Date: April 7, 2025
To: Prospective Bidders
From: Napa Valley Transportation Authority (NVRTA)
Re: LETTER OF CLARIFICATION NO. 2 to No. 25-R24 – BMF EV CHARGER BUILDOUT

**Bidder Questions and Answers Matrix #2 for
25-R24**

BMF EV CHARGER BUILDOUT

ELECTRICAL SITE PLAN	DRAWING NO. E-01
	SHEET NO. 8 OF 10

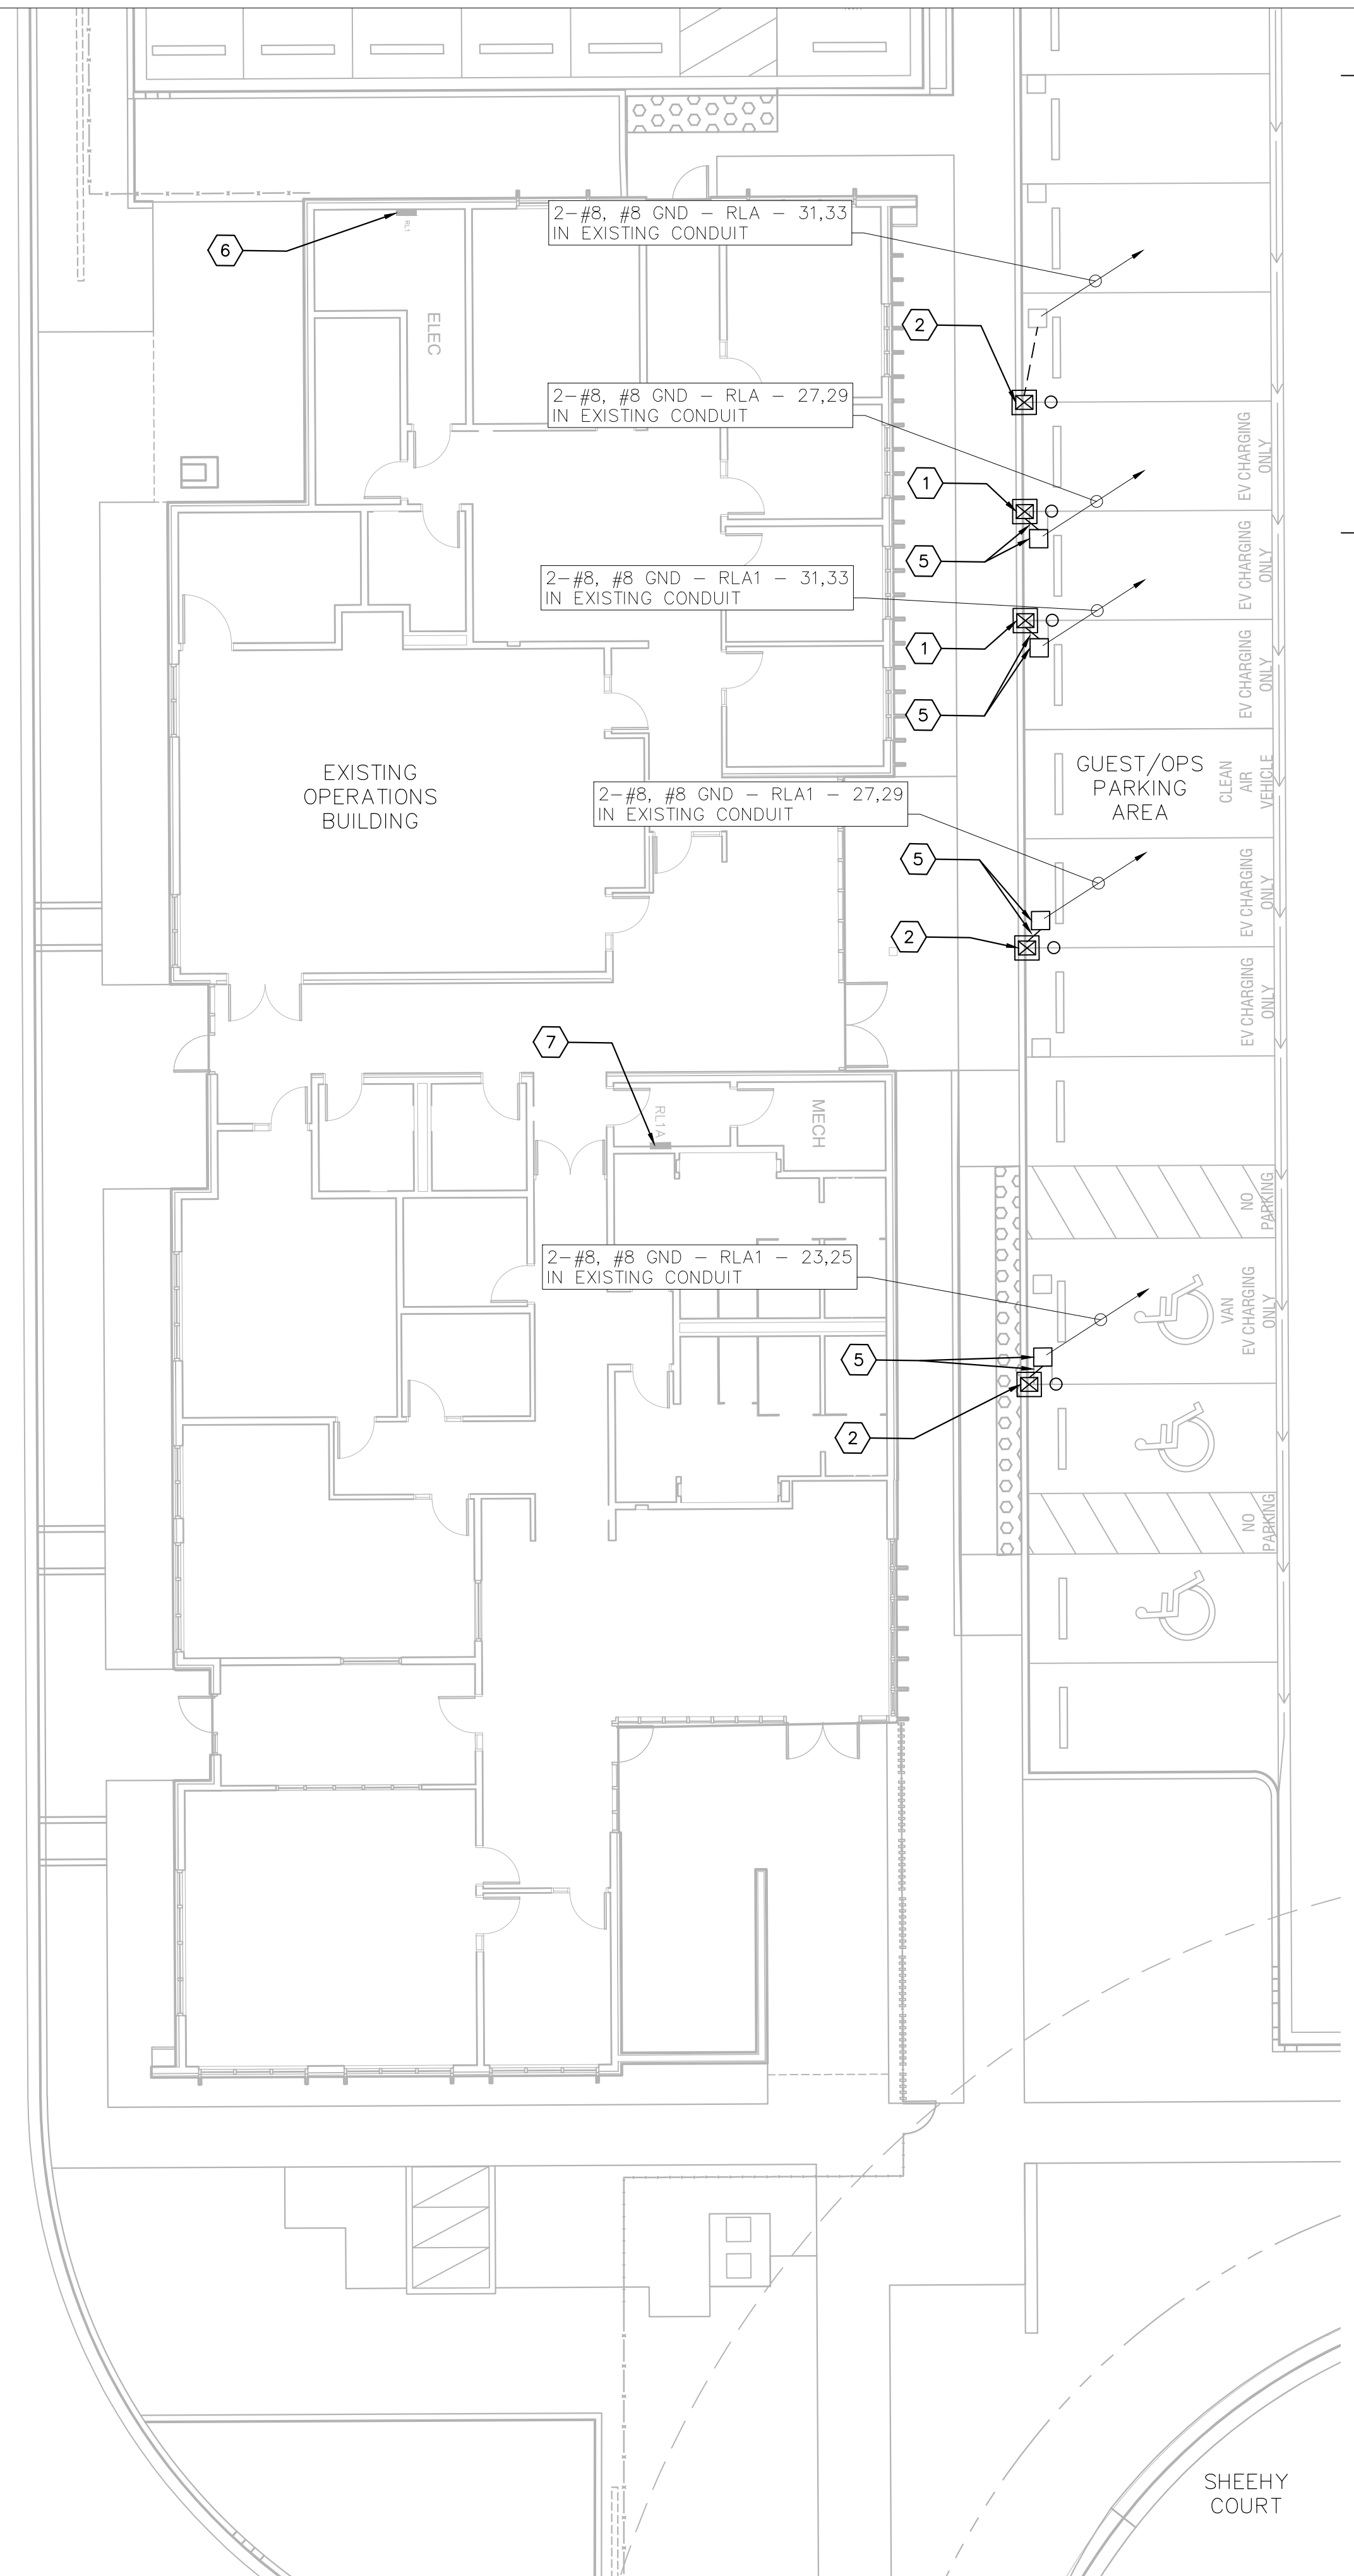
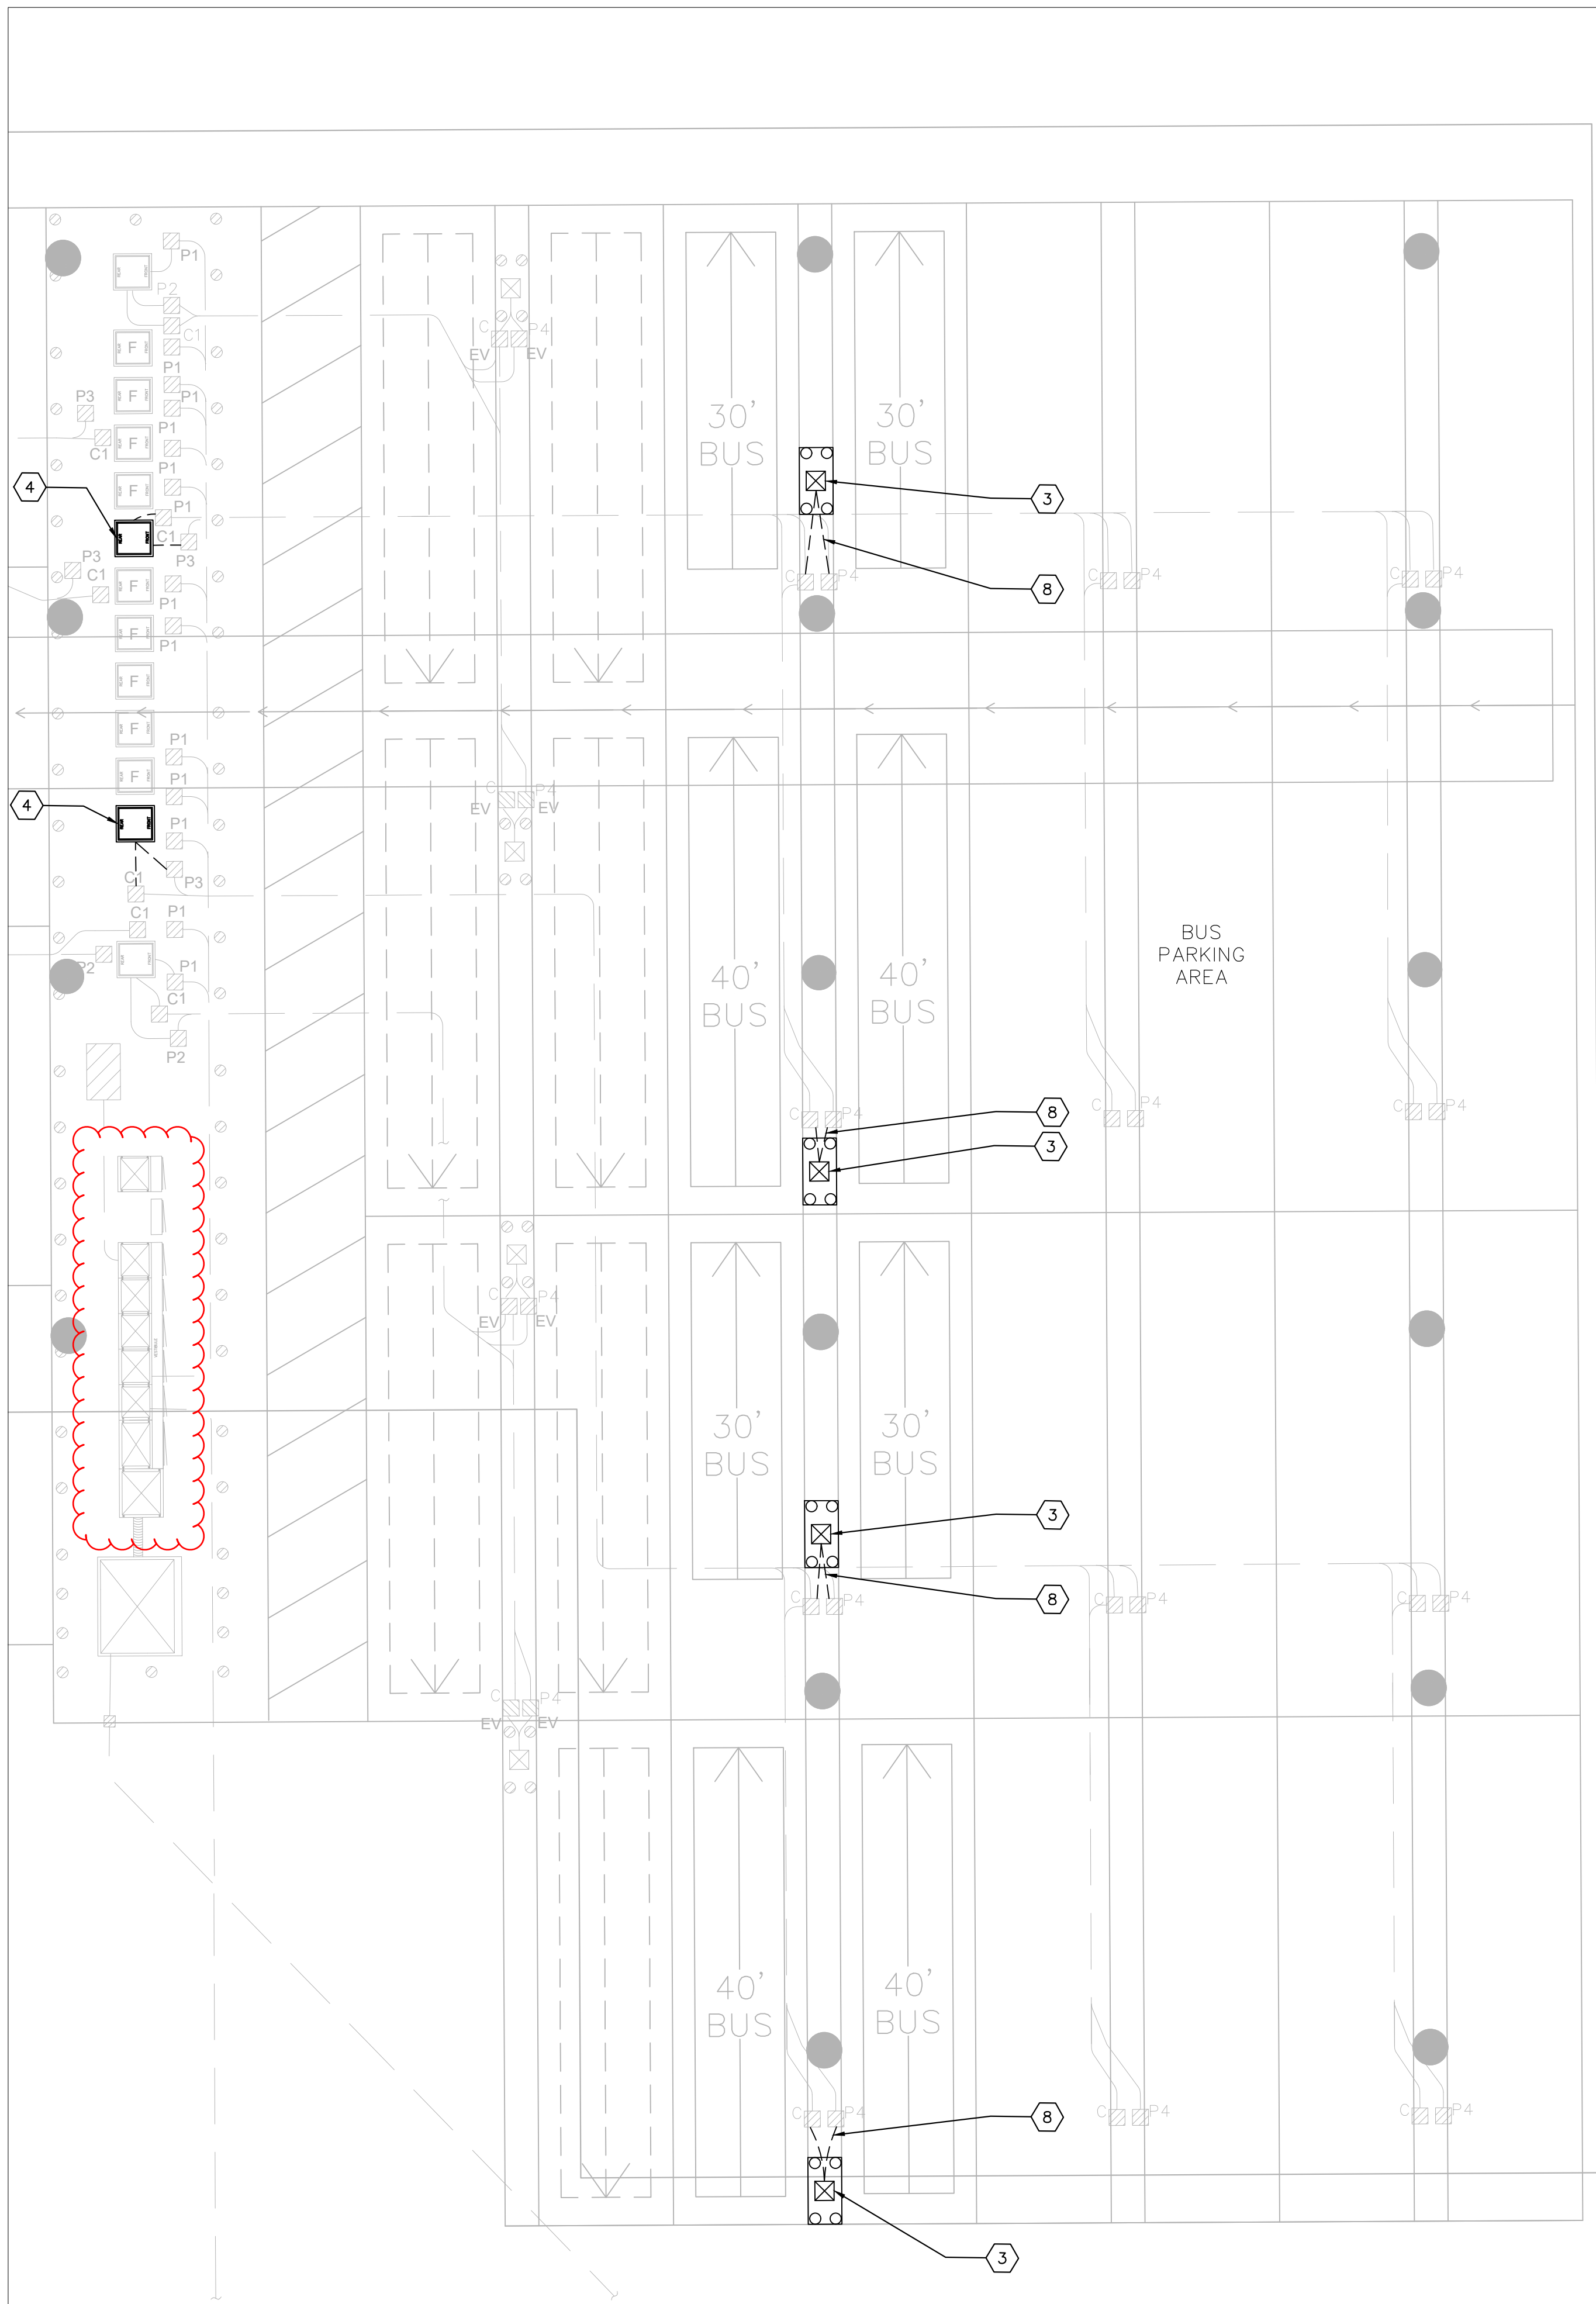
3. Bidder Submitted Question: *“Where on the plans is the main electrical service located? “MSB-EV”.*

3.		<p>Where on the plans is the main electrical service located? “MSB-EV”.</p>	<p><i>Please see attached plan sheet E-01 with red cloud indicating location of MSB-EV.</i></p>

Please see attached plan sheet E-01 with red cloud indicating location of MSB-EV.
